Fil	le	1994-0044 Name: <u>Bishop Const. Shop/Warehouse – Site Plan Review -592 North Commercial Drive</u>	
P	S	1 f. '/	
r	c	A few items are denoted with an asterisk (*), which means they are to be scanned for permanent record on the ISYS	
e	a	retrieval system. In some instances, items are found on the list but are not present in the scanned electronic development	
S	n	file because they are already scanned elsewhere on the system. These scanned documents are denoted with (**) and will	
e	n	be found on the ISYS query system in their designated categories.	
n t	e d	Documents specific to certain files, not found in the standard checklist materials, are listed at the bottom of the page.

FILE #44-94 TITLE HEADING: Site Plan Review - New Office

**Building - Bishop Construction**

LOCATION: 592 N Commercial Drive

SITE PLAN

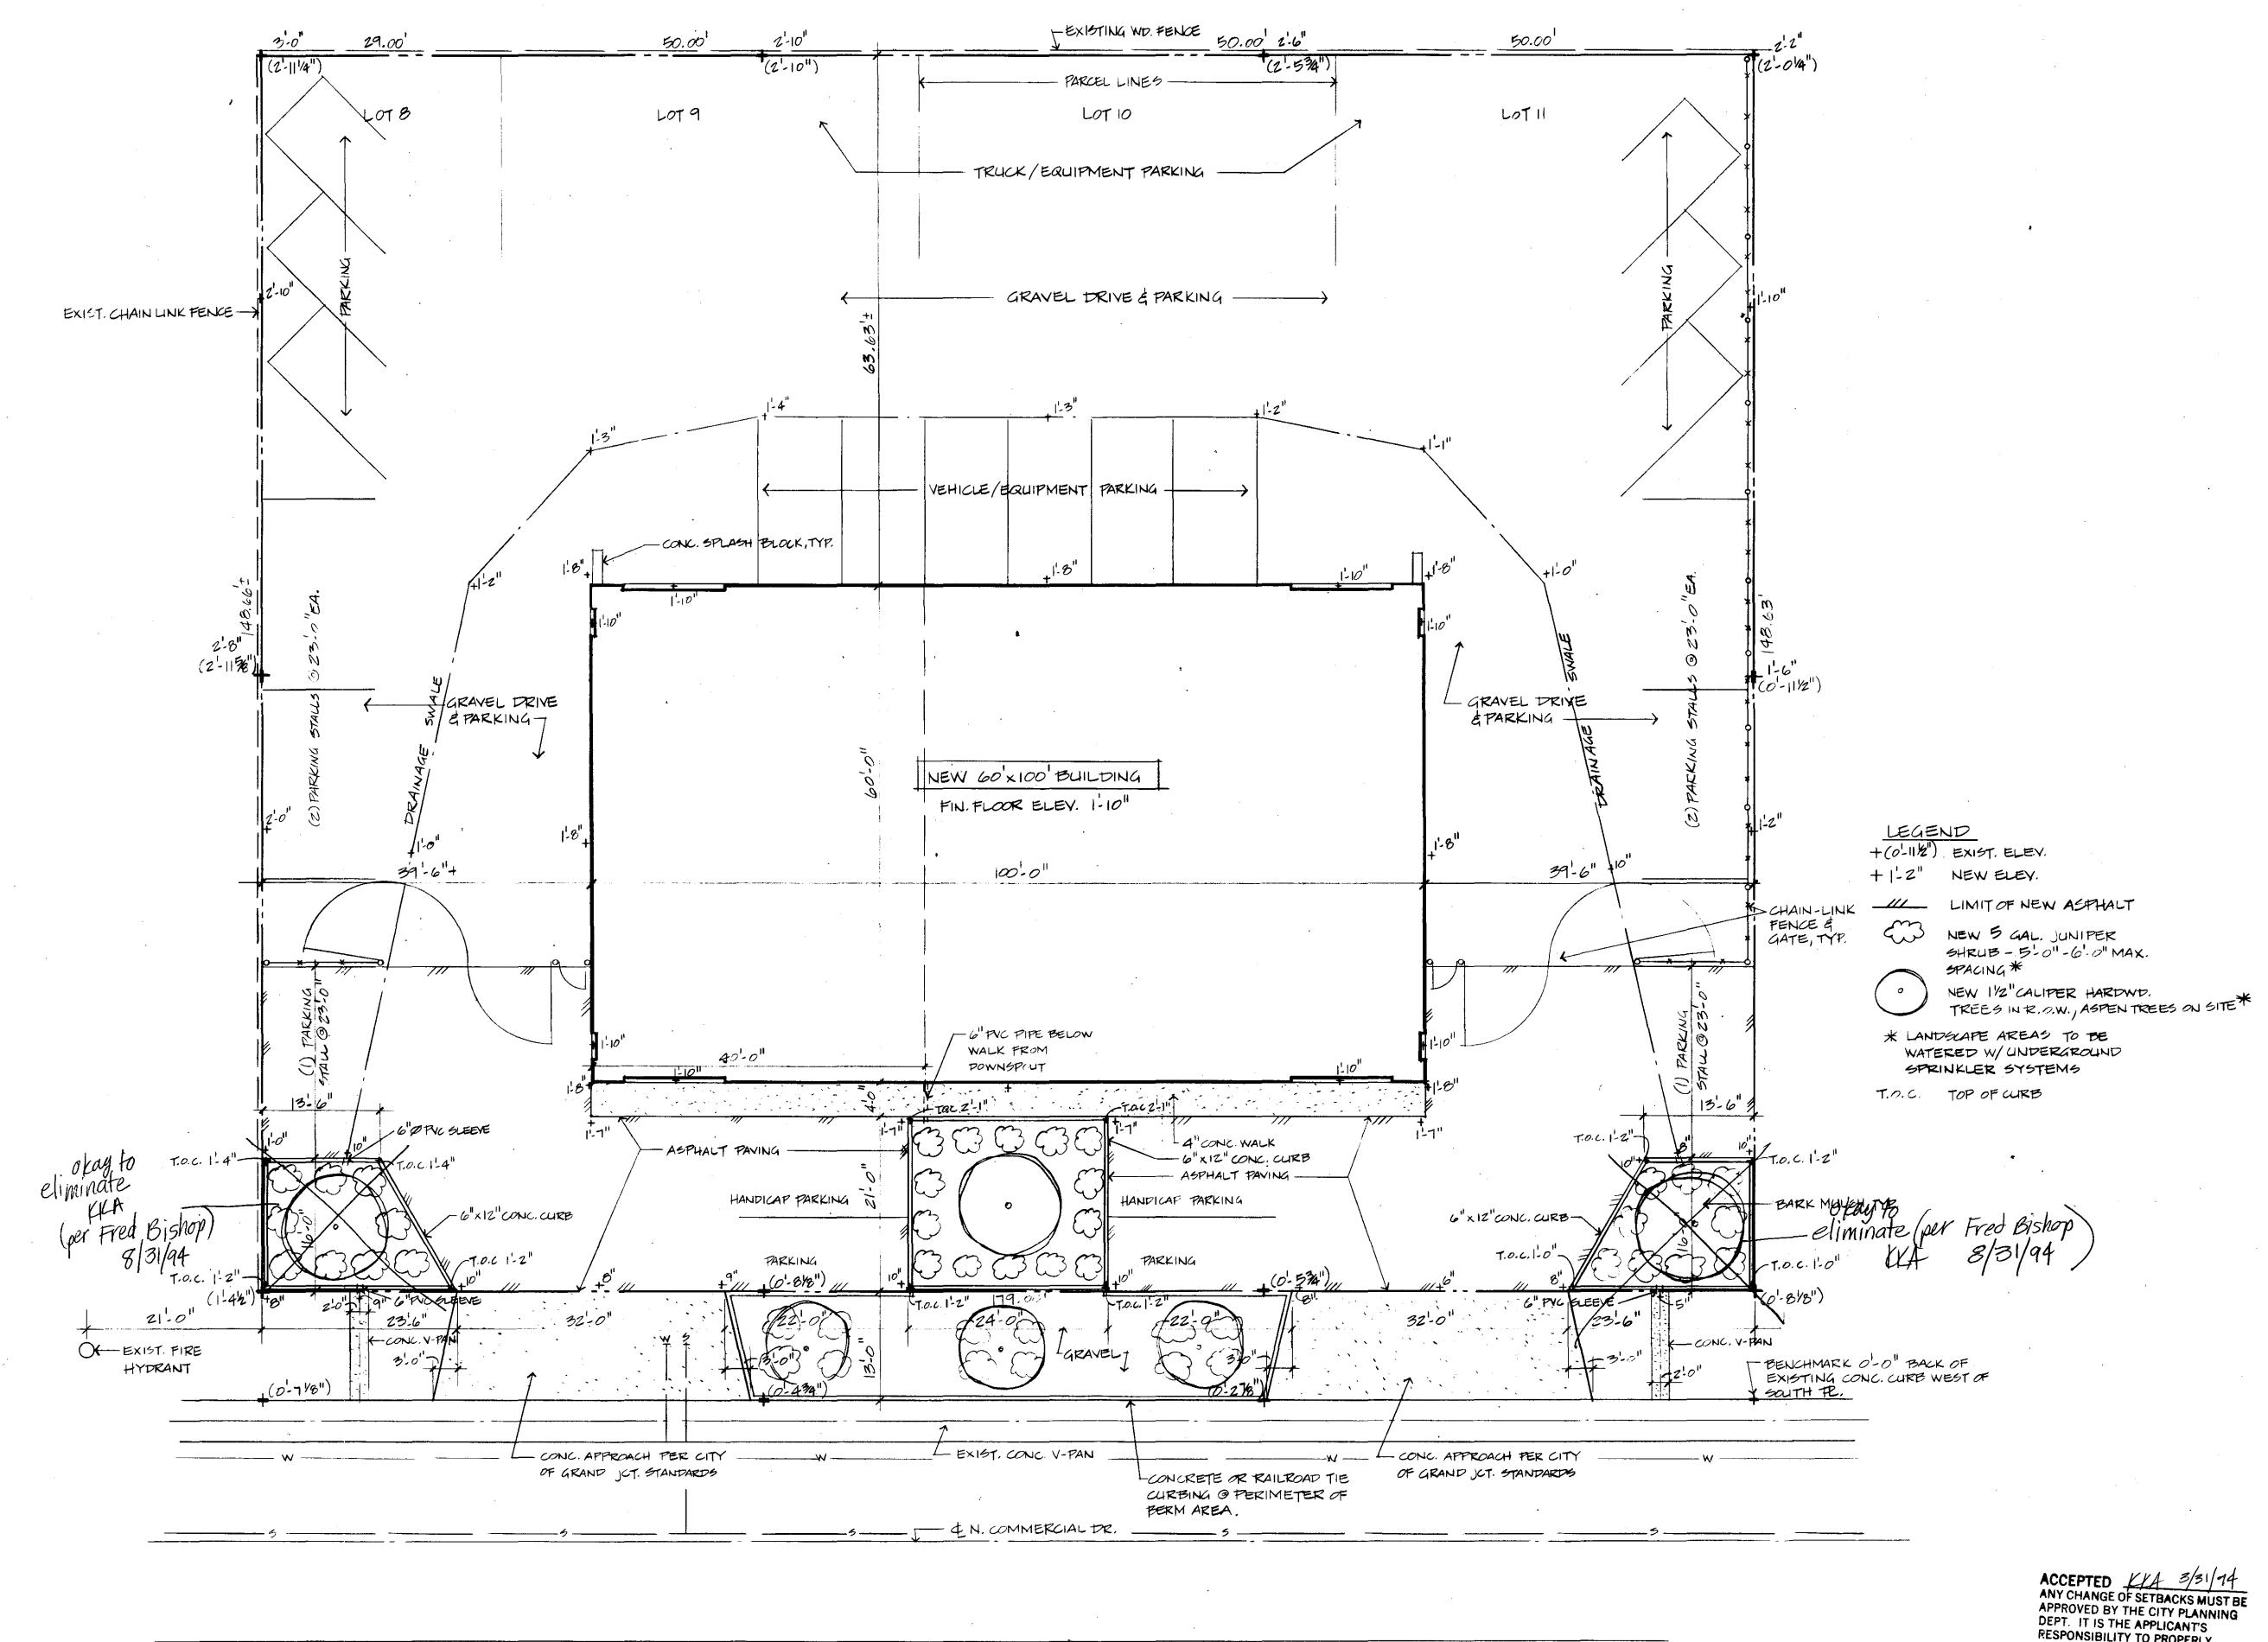
- 1. All primary circulation/parking areas must be paved in this case, all areas in front of the gates, not just the front area.
- 2. Total landscape requirement on site is approximately 1,500 s.f.; of which, approximately 1,062 s.f. is shown on the proposed plan. Since the area in the right-of-way between the driveways must also be landscaped, this area can be considered to meet the balance of the on-site requirement. Revise plan to show landscaping in right-of-way between driveways.

- 3. Minimum planting size for shrubs is 5 gallon (plan indicates 2 gallon).
- 4. Watering plantings by hand and with runoff is not acceptable, especially since the plantings will be along a roadway. The Zoning and Development Code requires an underground, pressurized irrigation system for all landscaped areas.

- All primary circulation/parking areas must be paved--in this case, all areas in front of the gates, not just the front area.
- 2. Total landscape requirement on site is approximately 1,500 square feet; of which, approximately 1,062 square feet is shown on the proposed plan. Since the area in the right-of-way between the driveways must also be landscaped, this area can be considered to meet the balance of the on-site requirement. Revise plan to show landscaping in right-of-way between driveways.

- 2. Minimum planting size for shrubs is 5 gallon (plan indicates 2 gallon).
- 3. Provide more detailed information on plant species and total number of each.

- 4. Watering plantings by hand and with runoff is not acceptable, especially since the plantings will be along a roadway. The Zoning and Development Code requires an underground, pressurized irrigation system for all landscaped areas.

March 25, 1994 Mr. Steve Colony, Project Manager Alpine C.M., Inc. 1111 South 12th Street Grand Junction, CO 81501 RE: Bishop Construction Office Dear Steve, The red-lined drawing you provided for the proposed Bishop Construction office addresses most of the review agency comments. The revised finished floor elevation is acceptable to the City Development Engineer, and the revision to the fencing and pavement will meet site development standards; however, the following must still be addressed: Are the areas in front of the gates next to the fence

on either side still to serve as parking stalls? so, please label as such.

- Note that <u>all</u> landscape areas are to have a pressurized, underground irrigation system--delete any reference to watering with site and roof drainage and hand watering.
- Aspen clumps are acceptable in the on-site planter areas, but are not acceptable street trees within the public right-of-way. Recommend something hardier such as an ash, locust or even flowering fruit tree.
- The landscaped area within the right-of-way must have some sort of containment around it (e.g. curbing). It must also include 40% coverage by shrubs. Suggest that it have wood mulch to match other on-site landscaped areas rather than gravel.
